T. W. Quigley
Environmental Project Leader
Sand Rock Mill
Minerals Department

Re: Conoco's Response to NRC Comments on Sand Rock Mill Project - NRC
Docket No. 40-8743

Comment No. 2

FIGURE 5.7-10A SIEVE-ANALYSIS FOR THE COARSE PORTION OF TAILING CYCLONE

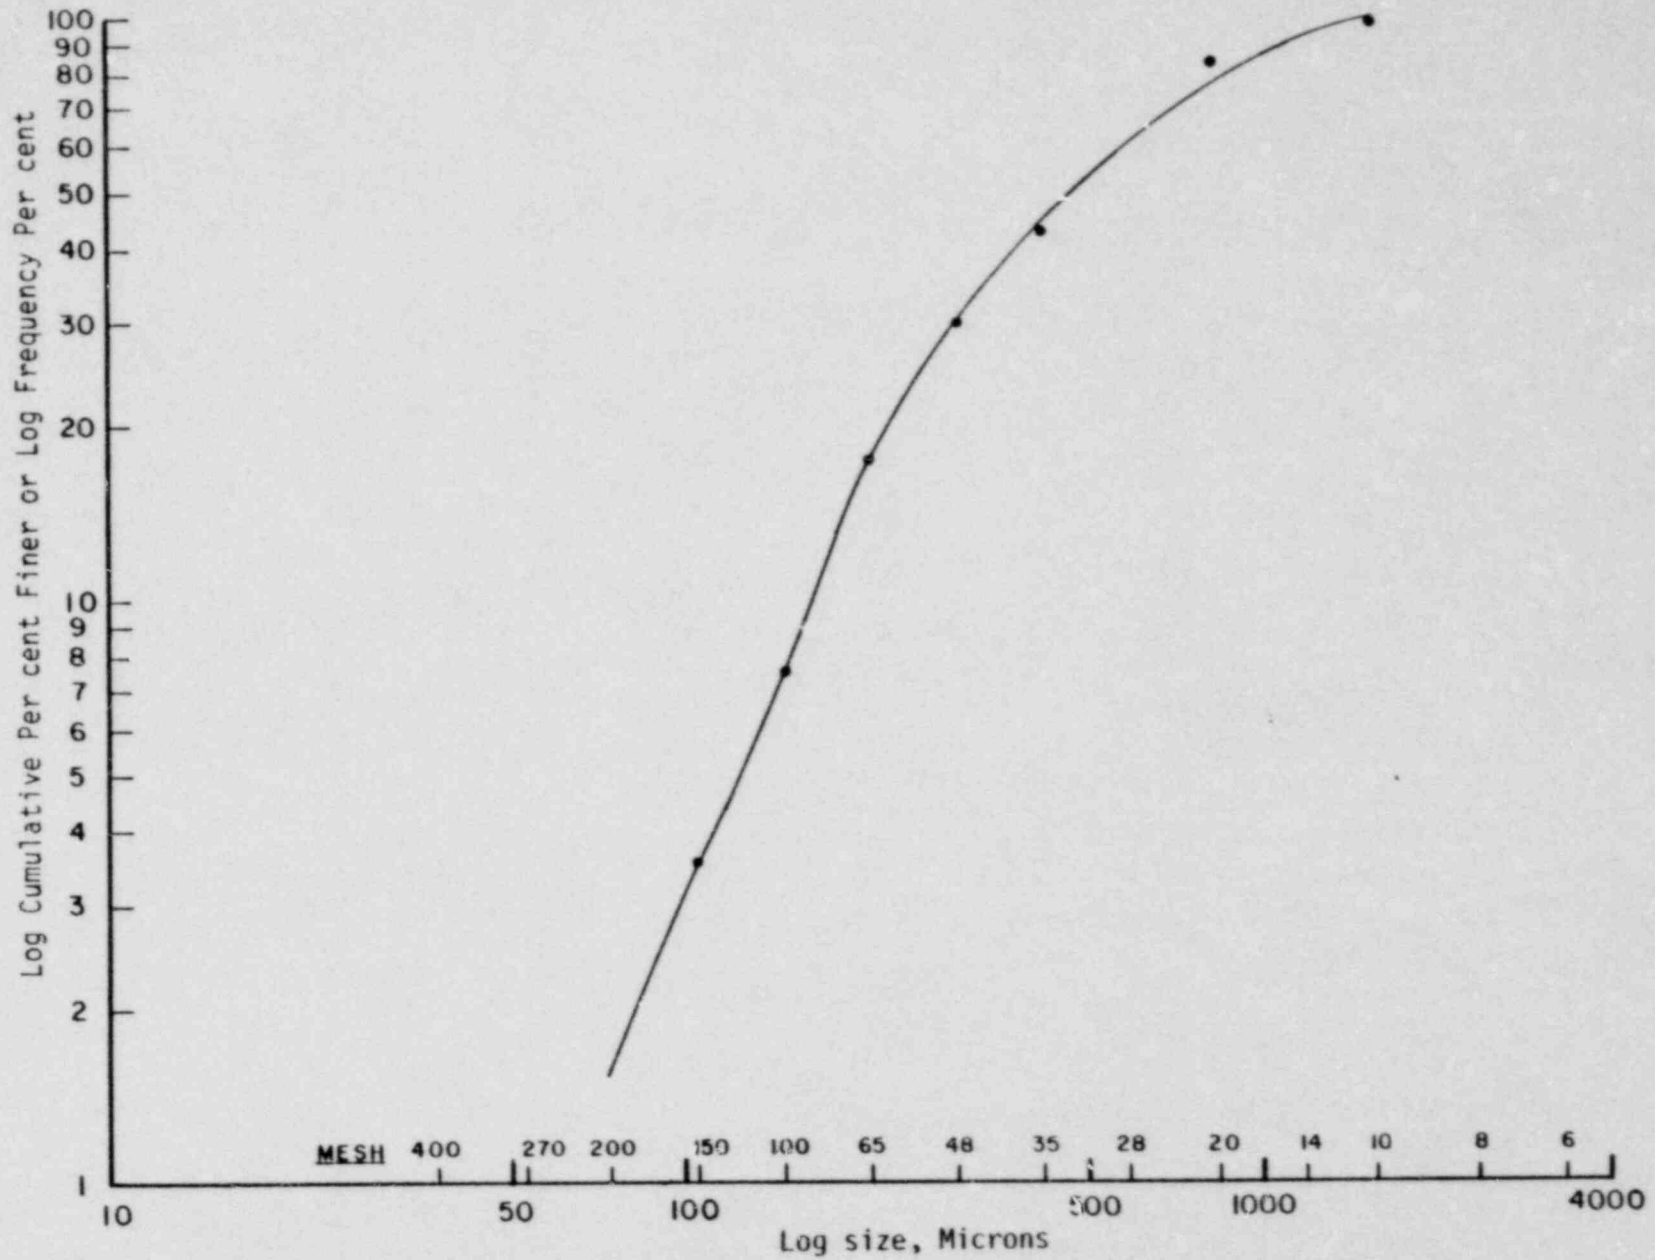
Submit computations for the design of underdrains to verify that all filter materials meet filter criteria, and that the system will function reliably and effectively.

The filter material will be the coarse fraction of the cycloned tailings at the evaporation pond. A sample of the coarse fraction of cycloned tailings taken from Rocky Mountain Energy's Bear Creek Mine was analyzed for particle size. Bear Creek tailings and crushed Sand Rock ore samples have nearly identical grain-size distribution. Figure 5.7-10A presents the sieve curve for this analysis. Median diameter is 0.48 mm and the uniformity coefficient (D_{60}/D_{10}) is 3.4. The coarse portion of the cycloned tailings at Sand Rock is expected to be similar to this sand sizing. The fifty percent size of the filter pack should be approximately two times greater than the median size of the tailings material. Filter packs can generally be 4 to 6 times greater than the size of the tailings material before problems associated with tailings infiltration develop. The use of a filter pack whose size is only two times greater than the median tailings size should prevent tailings from excessively infiltrating the sand pack. The sand pack, with uniformity coefficient of approximately 3.5 and a median diameter of 0.48 mm should have a permeability of 3×10^{-3} to 1×10^{-2} (30,000 to 100,000 ft/yr). The permeability

of the sand-pack material will be at least 10 times as great as the horizontal permeability of the tailings material. This difference indicates that the transmitting capability of the sand pack will be adequate. A No. 20 (0.020 inches) slot size was selected as the perforation size in the drain pipe.
